SERVICE BULLETIN

N° 139-653

ATA 21 - KIT HEATING RETROFIT

This Service Bulletin is issued in order to provide the necessary instruction on how to perform the installation of kit heating retrofit P/N 3G2140P01311.

Figure 1

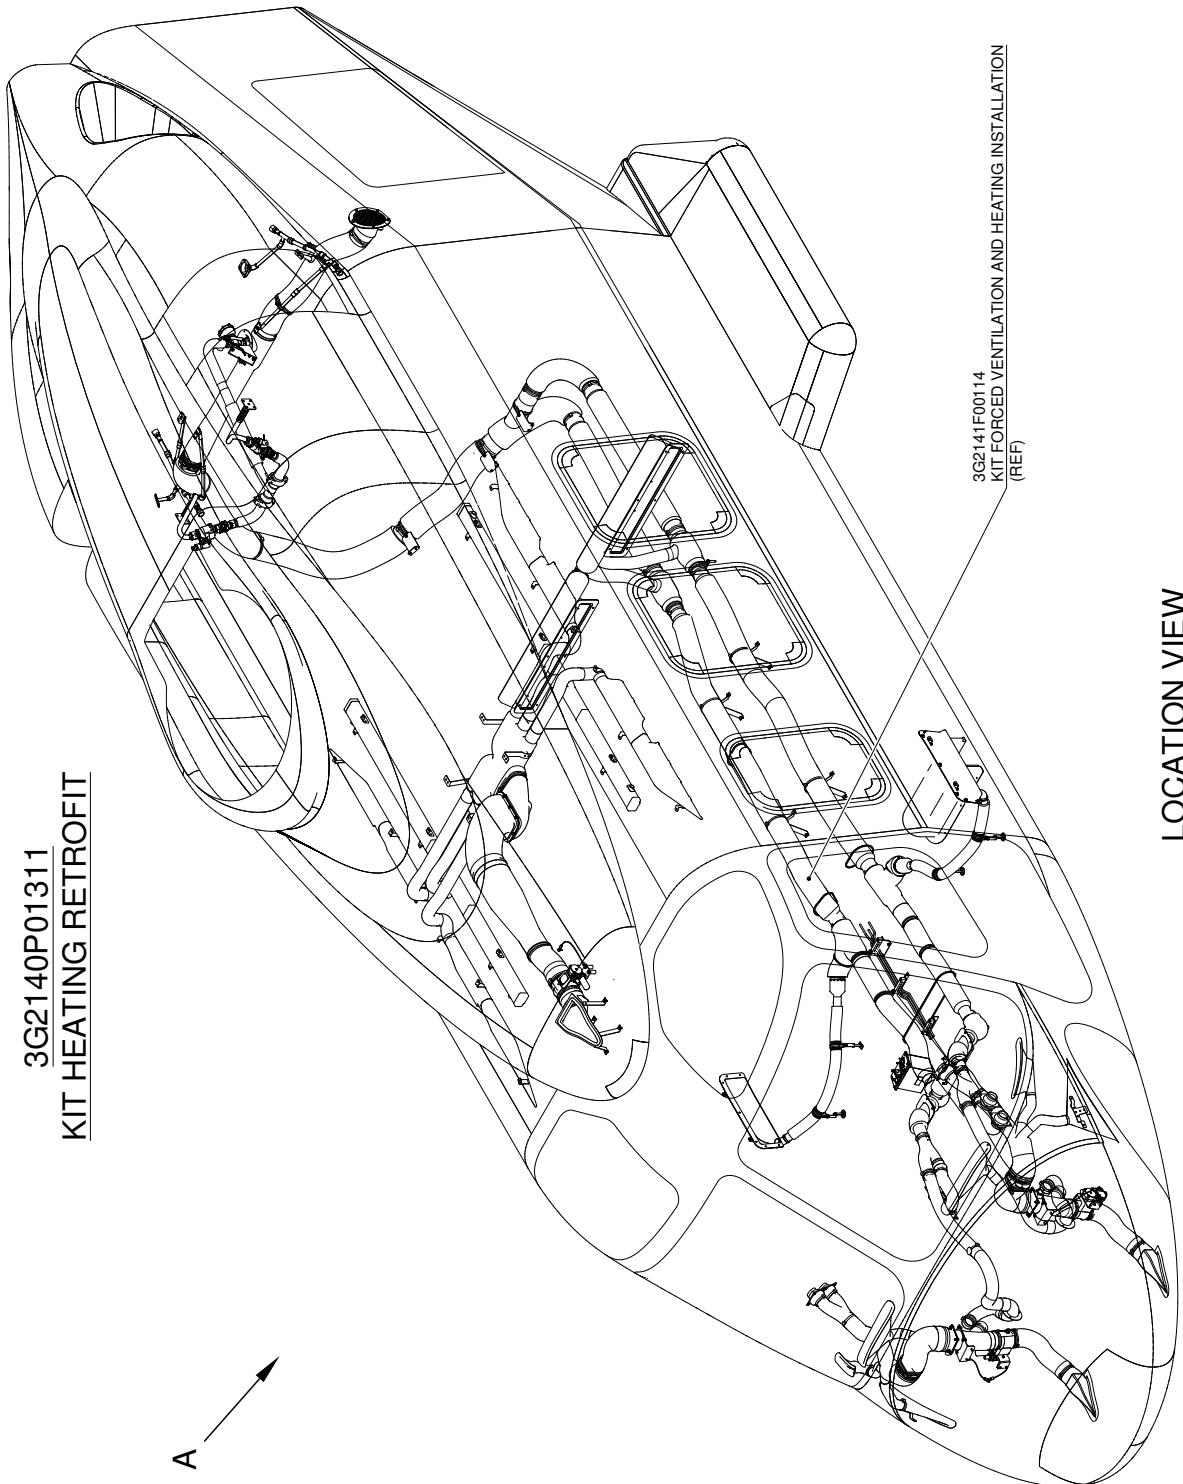
3. With reference to Figures 1 thru 3, perform the installation of kit heating retrofit P/N 3G2140P01311 as described in the following procedure:
 - 3.1 With reference to Figure 2 View B, remove heating cockpit control Panel P/N 3G2141V00353 from the interseat console.

Figure 2

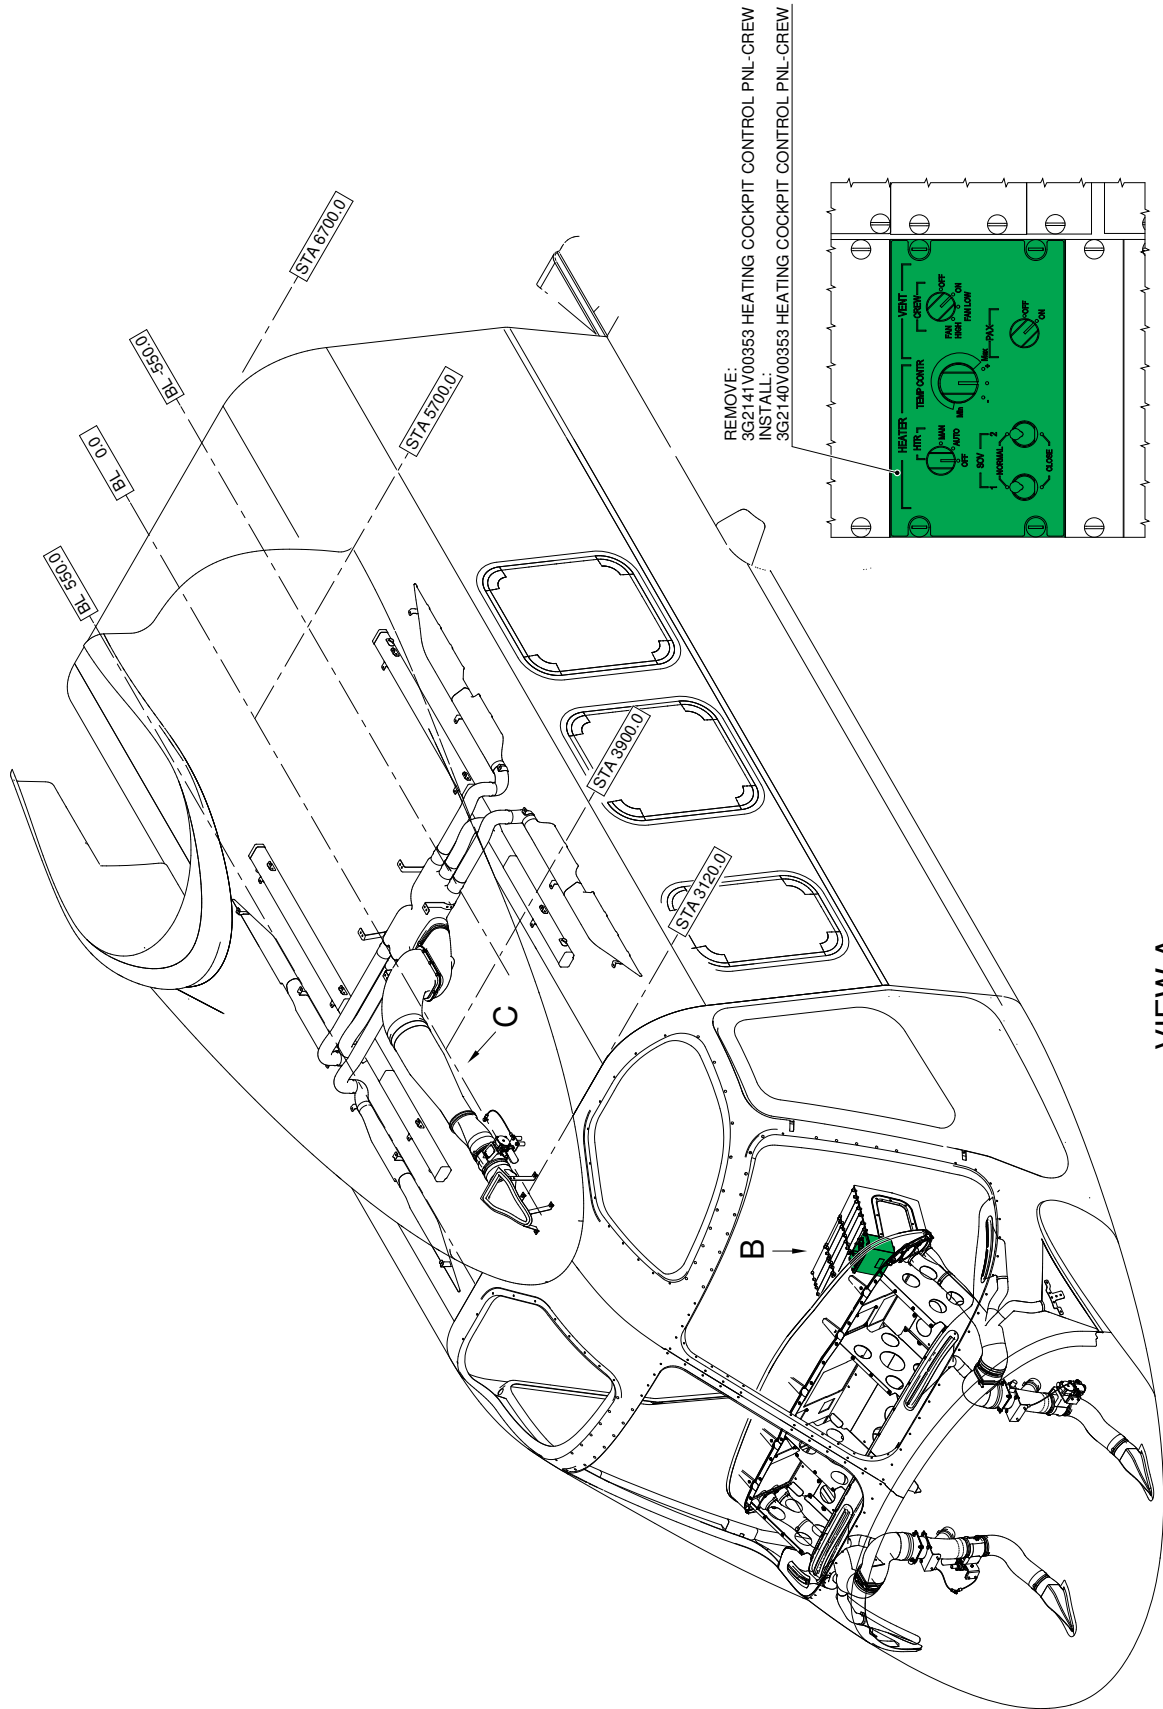
- 3.2 With reference to Figure 2 View B, install heating cockpit control Panel P/N 3G2140V00351 on the interseat console.
- 3.3 With reference to Figure 3 View C, remove the following components from the helicopter:
 - fan bracket P/N 20204-21;

Figure 3

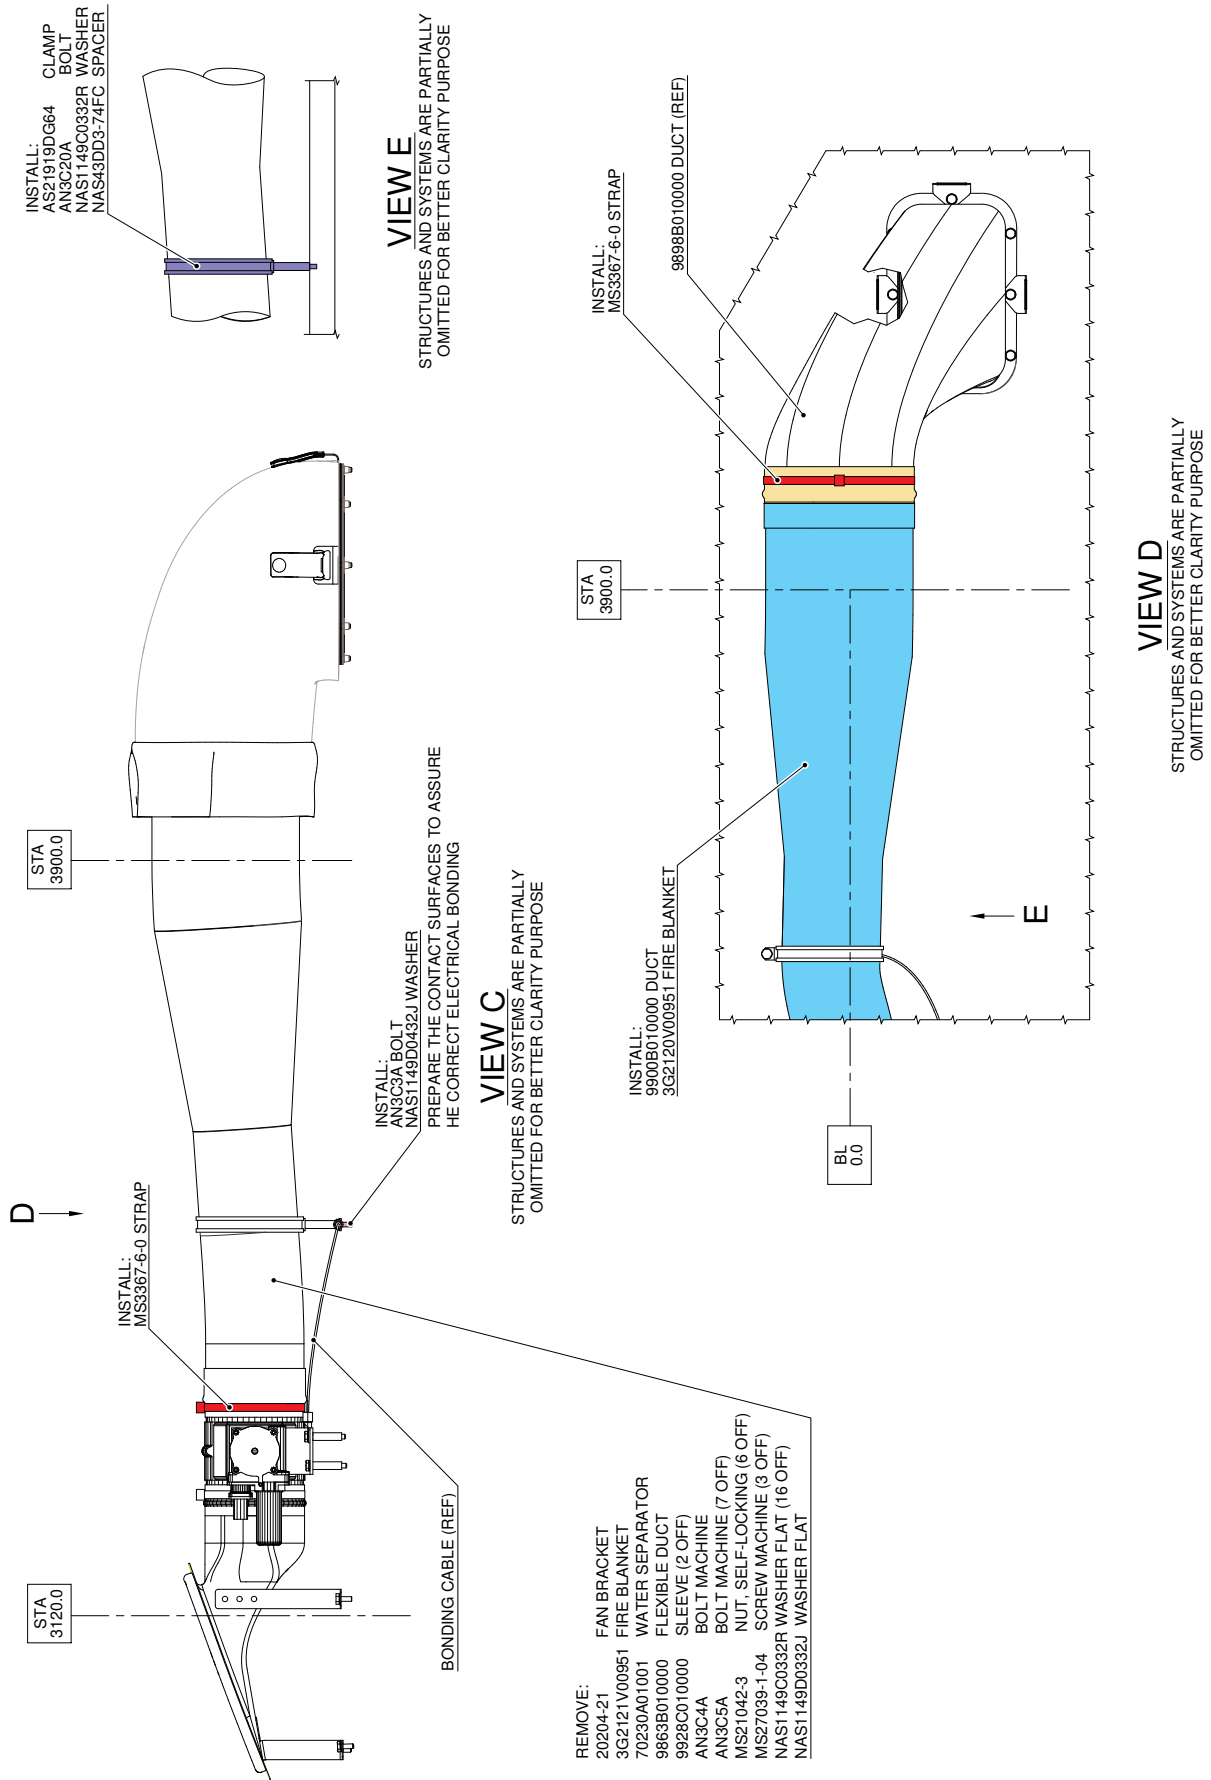
- fire blanket P/N 3G2121V00951;
- water separator P/N 70230A01001;
- flexible duct P/N 9863B010000;
- n°2 sleeves P/N 9928C010000;
- bolt P/N AN3C4A;
- n°7 bolts P/N AN3C5A;
- n°6 nuts P/N MS21042-3;
- n°3 screws P/N MS27039-1-04;
- n°16 washers P/N NAS1149C0332R;
- washer P/N NAS1149D0332J.

Prior to installation, interpose a layer of adhesive RTV 732 (C126) between duct P/N 9900B10000 and duct P/N 9898B010000.

- 3.4 With reference to Figure 3 View C and View D, install duct P/N 9900B010000 by means of n°2 straps P/N AW001CK06HS.
- 3.5 With reference to Figure 3 View D, install fire blanket P/N 3G2120V00951 on the duct P/N 9900B010000 previously installed.

- 3.6 With reference to Figure 3 View E, install clamp P/N AS21919DG64, bolt P/N AN3C20A, washer P/N NAS1149C0332R and spacer P/N NAS43DD3-74FC.
- 3.7 In accordance with AMP DM 39-A-20-10-01-00A-259A-A and with reference to Figure 3 View C, prepare the contact surfaces to assure the correct electrical bonding.

- 3.8 With reference to Figure 3 View C, fix bonding cable by means of bolt P/N AN3C3A and washer P/N NAS1149D0432J.
4. In accordance with weight and balance changes, update the Chart A (see Rotorcraft Flight Manual, Part II, section 6).
